# Agenda

## Planning Decisions Committee

6.30pm, Wednesday 10 February 2021

1. This report provides Council with an assessment of a planning permit application submitted for 4000/9 Robert St Collingwood, which seeks approval for PLN20/0359 - 4000/9 Robert St Collingwood VIC 3066 - Construction of a two storey addition, containing two additional dwellings (no permit required for use), above the existing four storey building with an associated reduction to the statutory car parking rate. The report recommends approval, subject to conditions.

Image 2: the proposed level 5 (ground floor of the proposed dwellings)

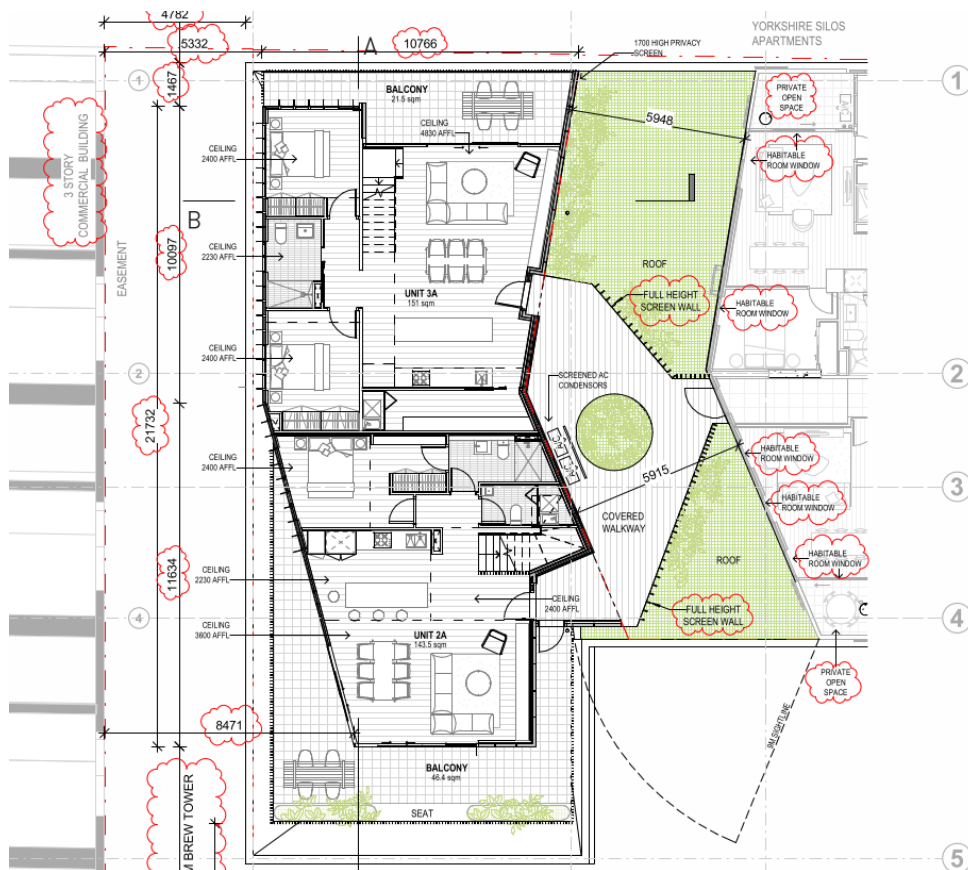
19. The ground floor of the dwelling will contain an open plan kitchen/living/dining, a bathroom and master bedroom with ensuite.
20. The ground floor of the dwelling will contain an open plan kitchen/living/dining, a bathroom and two bedrooms.
21. Both dwellings have their pedestrian entrance on the eastern side, connecting to the corridor and lift lobby of the existing 14 storey building to the east via a semi open walkway with a pergola cover. Full height screens are to be provided to the sides of the walkway to prevent overlooking to the adjacent apartments of the 14 storey building. The remainder of the podium between the proposed dwellings and the 14 storey building is to be landscaped.

*Image 6: Views of the proposed additions from Robert Street (eastward)*

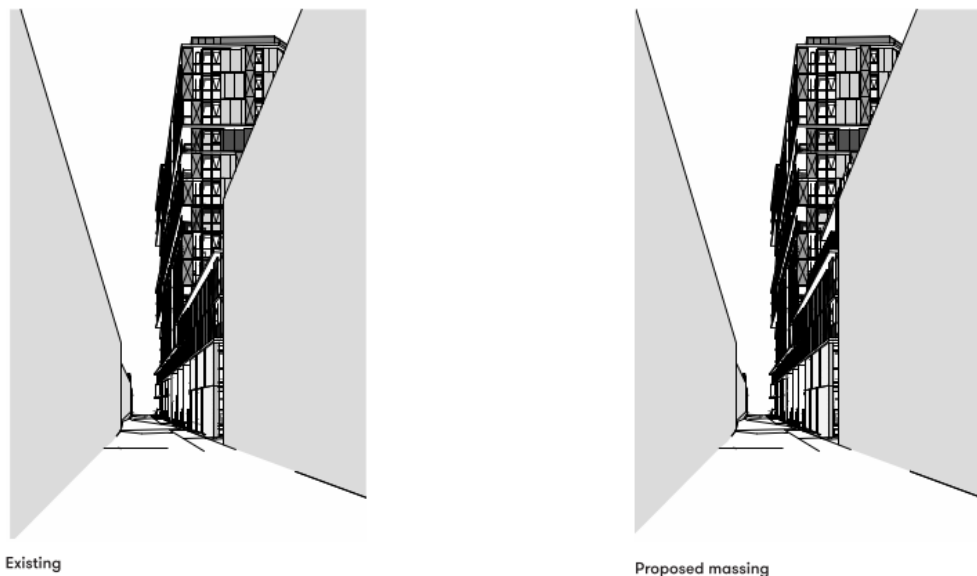
114. The additions will be set back from the Mansard Lane interface by 550mm (with the proposed fins encroaching this setback) for a length of 10.11m and to the maximum 6 storey 18.66m height to the north-west before raking away from the laneway to the south west with a maximum setback of 2.37m at the sixth floor and 3.5m at the fifth floor, which extends further to the south. With the proposed raked wall, inclusion of fins and balustrading and a mixture of materials the proposed design provides a good degree of articulation to the massing of to the west.

Image 10: The second bedroom of dwelling 2A.

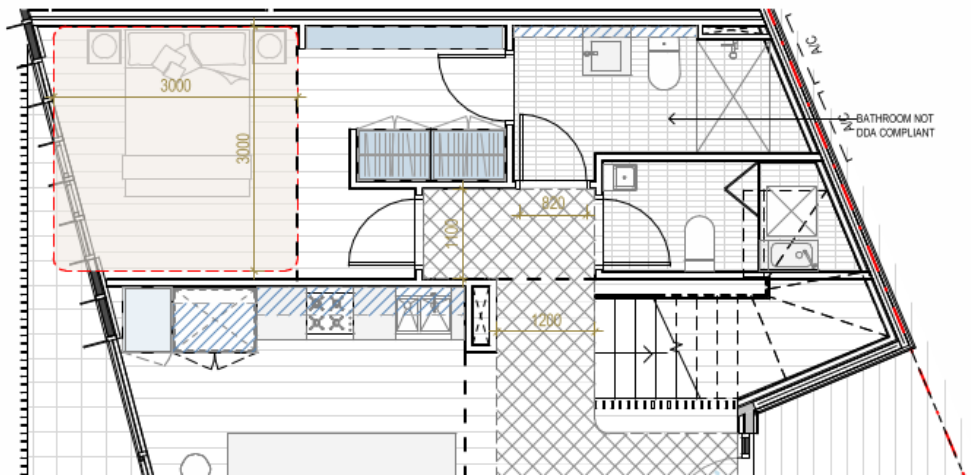
173. This Standard notes that main bedrooms and all other bedrooms should have a minimum width and a minimum depth of 3m and 3.4qm, 3m and 3sqm, respectively.
174. The current proposed additions are largely compliant with the bedroom dimensions required under this Standard. The ground floor bedroom of Dwelling 2A is marginally non-compliant with the minimum dimensions due to the rake of the western wall. The bedroom is however a secondary bedroom, with the main bedroom fully compliant with Standard D24. The non-compliant bedroom is also of a generous size incorporating an additional transitional space and open robe giving it a total area of 13sqm excluding the robes as illustrated in the image below. A variation to the Standard is subsequently considered appropriate.

166. If the proposed first floor study of Dwelling 2A is used as a third bedroom, it would also fall short of the above requirements. However, as a study it is acceptable. It is also reasonable for a generous study to form part of a new dwelling proposal, particularly through increased working from home arrangements brought about by Covid-19 restrictions.
